Aumsville, Oregon
Wastewater Treatment Plant Improvements
ADDENDUM NO. 1

OWNER: **The City of Aumsville, Oregon**

FROM: Westech Engineering, Inc.

DATE: **June 24, 2026**

DRAWING
C209
65 223
JOB NUMBER
2599.3220.0

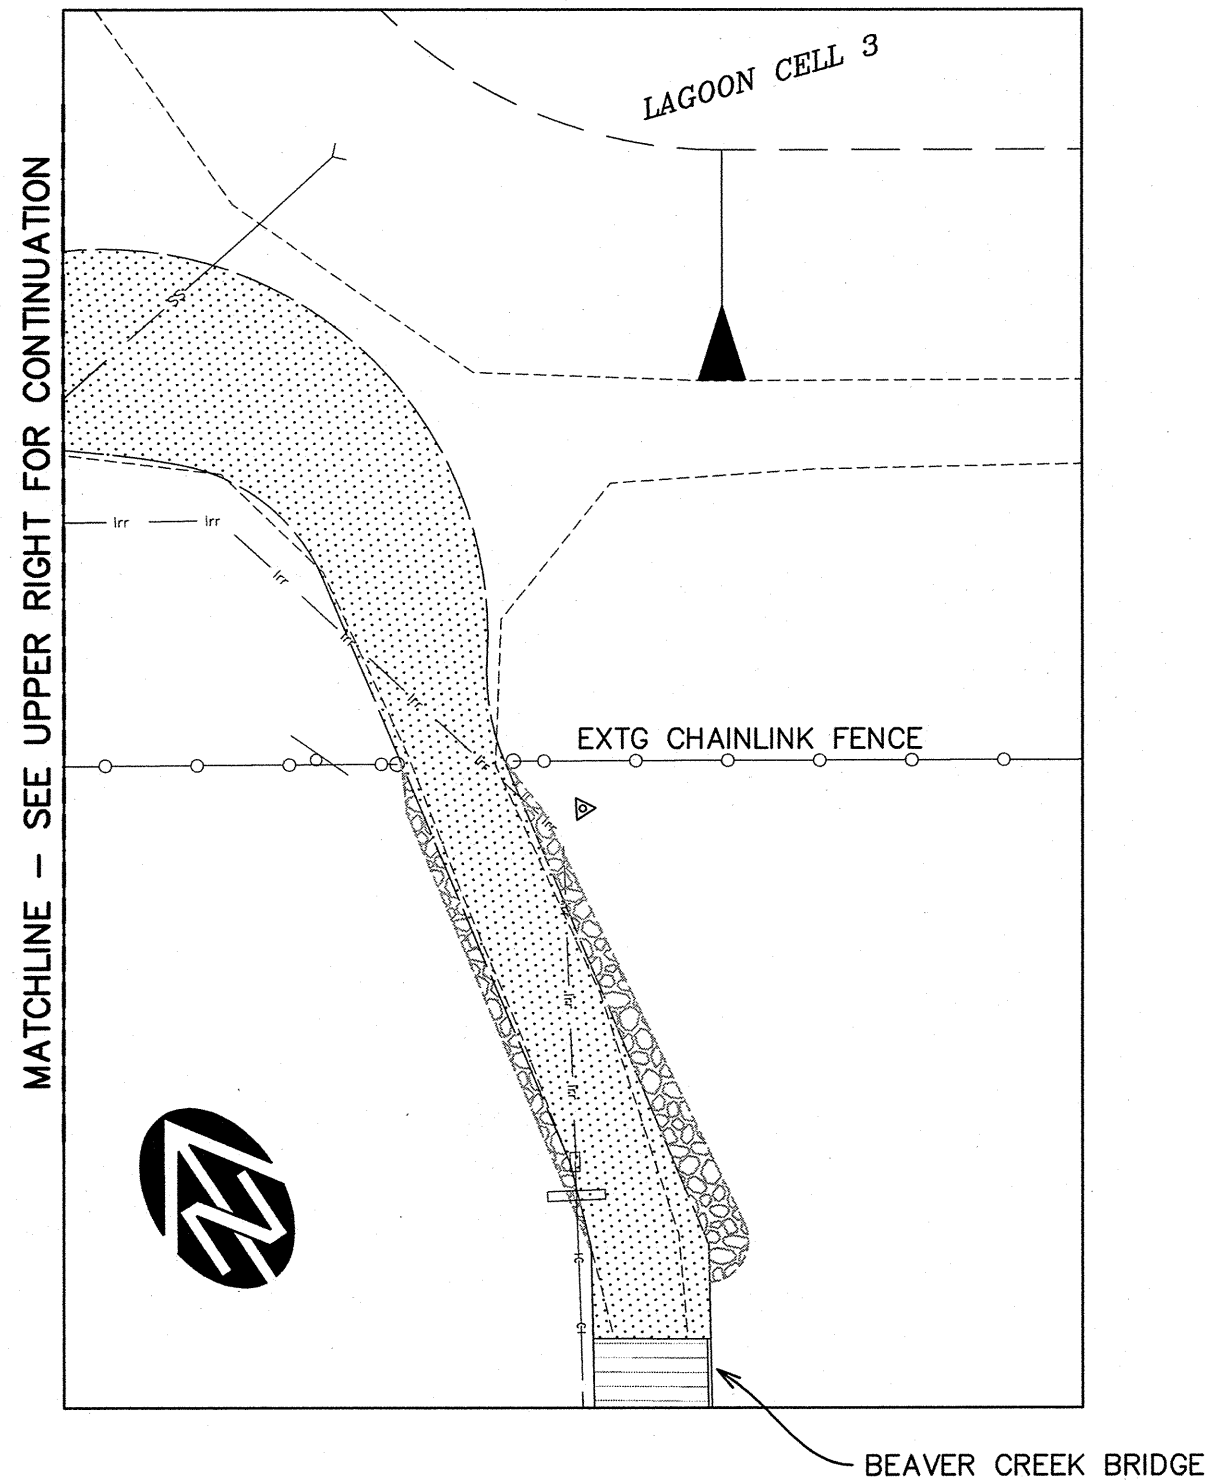
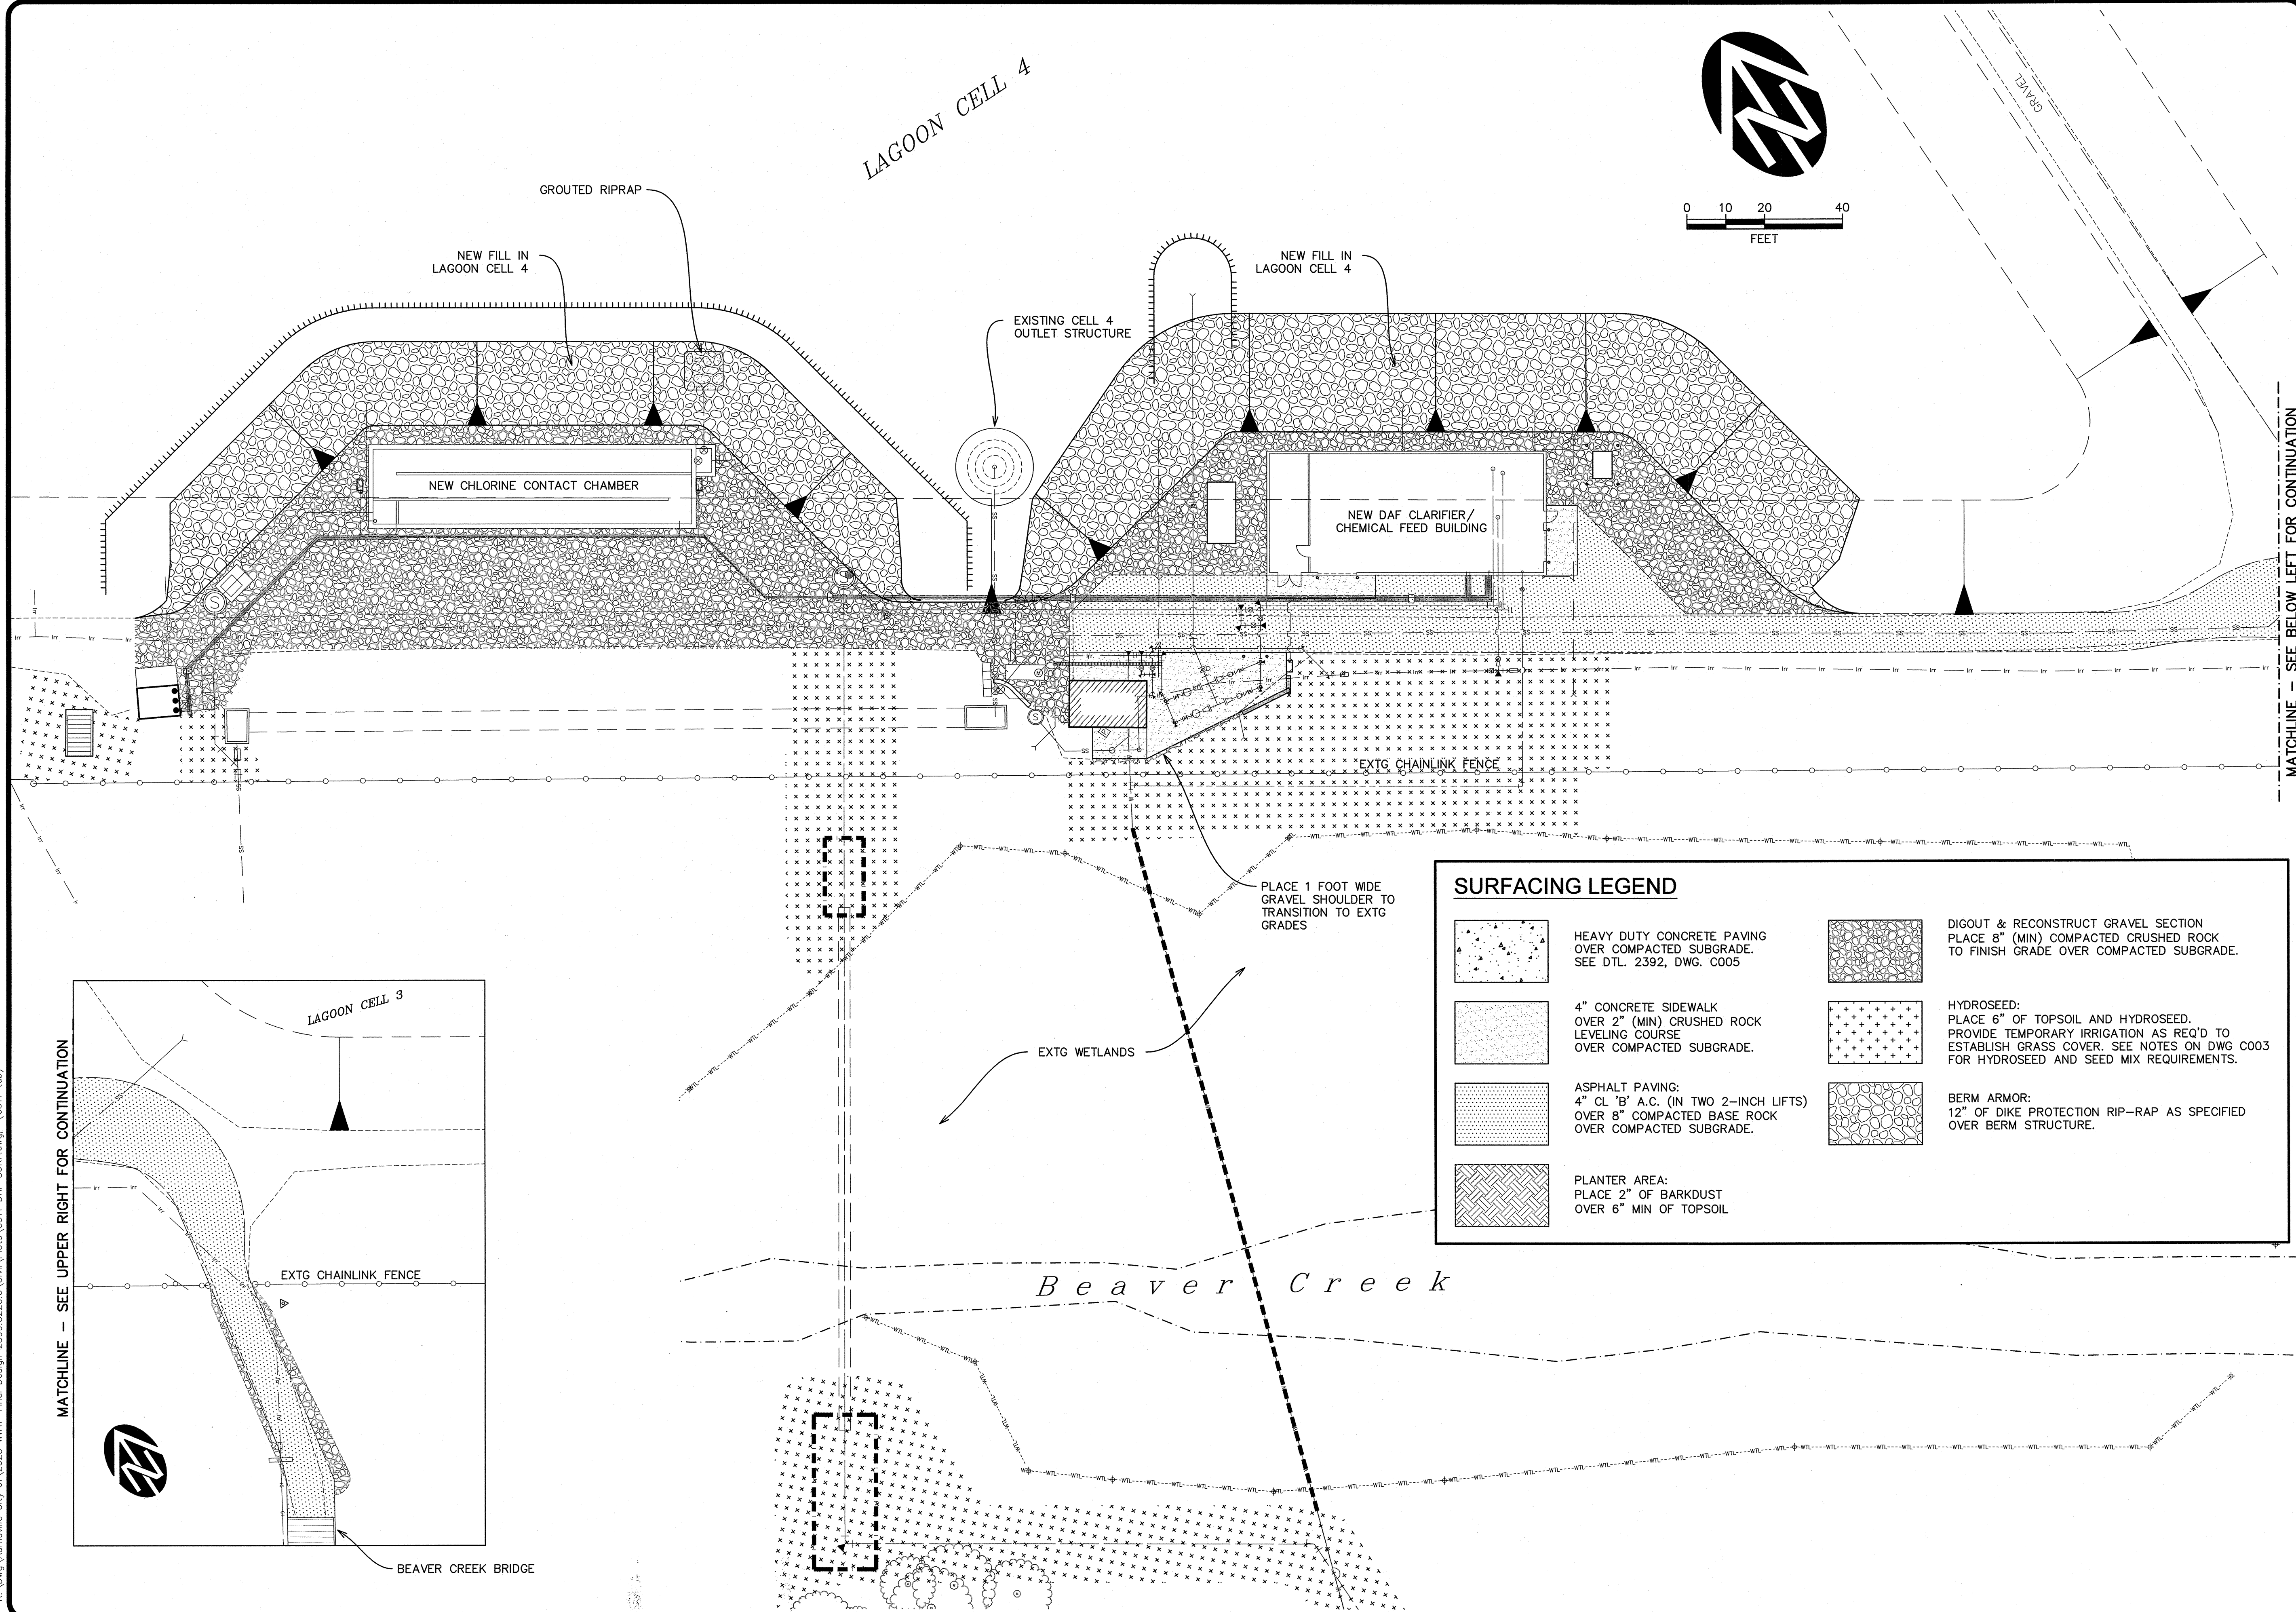
- 10. Drawing C209, (SBR Surfacing Plan).
 - a. Delete this sheet entirely and replace with the revised drawing C209 attached hereto. The surfacing limits remain unchanged. The changes to this drawing include a requirement to compact the subgrade for the Heavy Duty Concrete Paving, the Concrete Sidewalk, Asphalt Paving, and the Digout & Reconstruct Gravel sections.

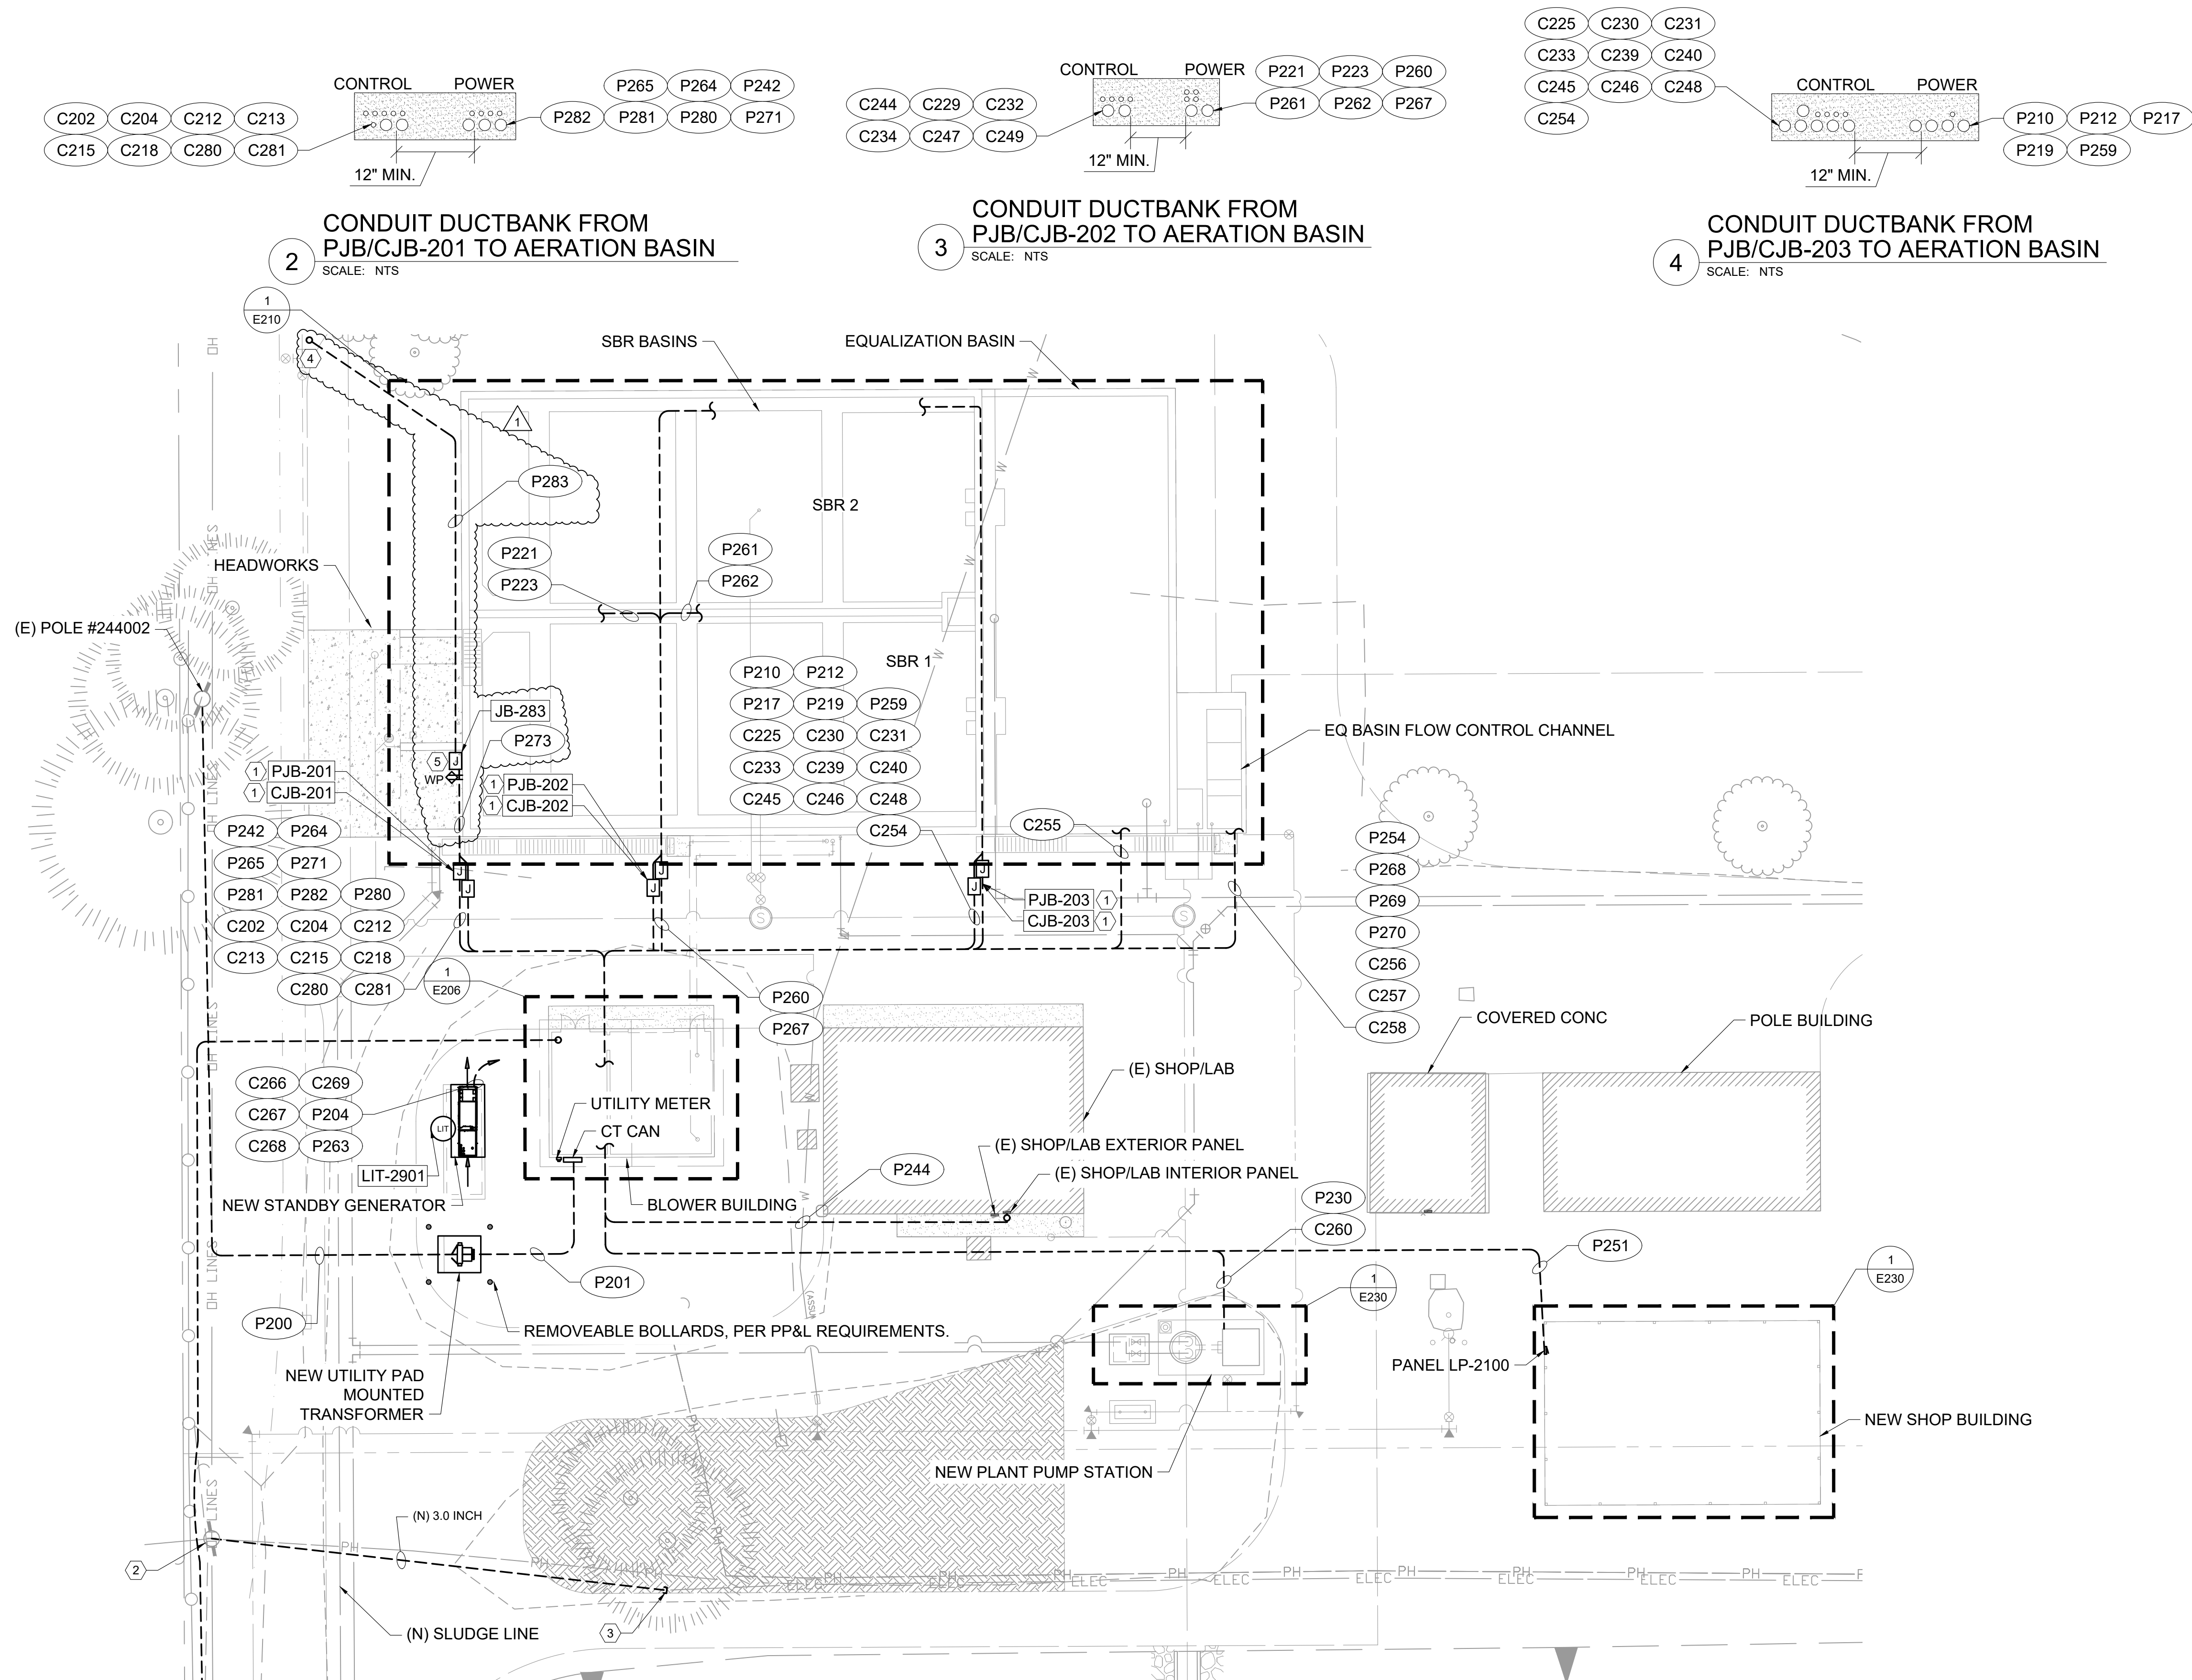
15. Drawing E205, (SBR Building & Basins Electrical Site Plan).
 - a. Delete this sheet entirely and replace with the revised drawing E205 attached hereto. Added sheet keynote #4 & #5. Added conduit runs P273 & P283. Added JB-283. Added keynotes for sheet keynote #4 & 5.
